TRANS/WP.29/GRSP/2004/1
20 February 2004

PROPOSAL FOR DRAFT AMENDMENTS TO REGULATION No. 14
(Safety-belt anchorages)

Transmitted by the expert from Spain

Fig 1: rigid buckle, articulated

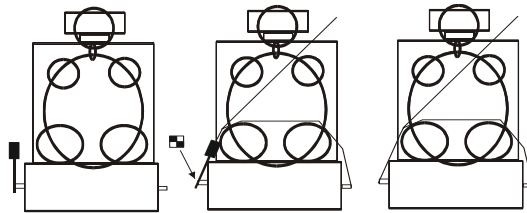
Fig 1.1: when we change the rigid buckle by a strap, contact areas between dummy and belt remain unchanged

Proposal: pivoting point should be the effective anchorage

Fig 2: rigid buckle fixed

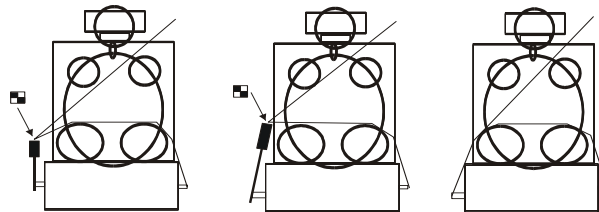
Fig 3: articulated buckle; but when we change it by a strap, contact areas are changed too; effective anchorage is not the pivoting point
